Access Compliance Report

Public Rights-of-Way

(Curb Ramps)

Intersection ID: 42761	Main Street: ERWIN_RIDGE_AV	Cross Street: OCONEE_LN	Location: W
ADA ID: F4AB2EB4226F	Ramp Type: PerpDiag	Initial Pass/Fail: Fail	Overall Compliance: No
Severity Score: 46.25			
Codes/Mitigation Info/Possible Solution		Field Measurements/Component Compliance

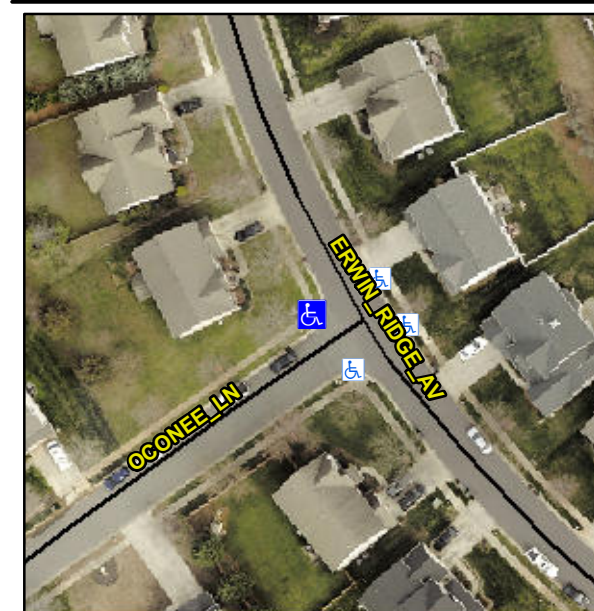
Not Found, R304.5.1, R304.2.2, R304.5.3

Compliance	Description	Data	Compliance	Description	Data
N/A	Ramp Length (in)	47.0	No	Ramp Slope (%)	8.8
No	Ramp Width (in)	44.5	No	Ramp XSlope (%)	10.2
N/A	Flare Type LT	N/A	N/A	Flare Type RT	N/A
N/A	Flare Slope LT (%)	N/A	N/A	Flare Slope RT (%)	N/A
N/A	Flare Traversable LT?	N/A	N/A	Flare Traversable RT?	N/A
N/A	Landing Length (in)	N/A	N/A	DWS Provided?	N/A
N/A	Landing Width (in)	N/A	N/A	DWS Contrast?	N/A
N/A	Landing Slope (%)	N/A	N/A	DWS Length (in)	N/A
N/A	Landing X Slope (%)	N/A	N/A	DWS Full Width?	N/A
N/A	Landing Curb? (Y/N)	N/A	N/A	DWS Offset (in)	N/A
N/A	Shared Landing?	N/A			
N/A	Gutter Ponding?	N/A	N/A	Gutter Slope (%)	N/A
N/A	Gutter Lip Ht (in)	N/A	N/A	Gutter X Slope (%)	N/A
N/A	Painted X Walk1?	No	N/A	Painted X Walk2?	No
	X Walk 1 Direction	To S		X Walk 2 Direction	To E
N/A	X Walk 1 Width (in)	N/A	N/A	X Walk 2 Width (in)	N/A
	X Walk 1 Slope (%)	0.3		X Walk 2 Slope (%)	7.6
	X Walk 1 X Slope (%)	8.8		X Walk 2 X Slope (%)	6.1

N/A	Ramp inside XWalk1?	N/A	N/A	Ramp inside XWalk2?	N/A
	Road Slope (%)	8.0	N/A	Clear Space?	N/A
	Road X Slope (%)	0.4	N/A	Clear Space to XWalk (in)	N/A
N/A	Any Obstructions?	N/A	N/A	Storm Grate/Utility Hazard?	N/A
	Obstruction Type			Storm Grate/Utility Type	
		N/A			N/A
			Yes	Surface Condition? (G/P)	Good

Remove & Replace Curb Ramp With Two New Directional Ramps or Equivalent.
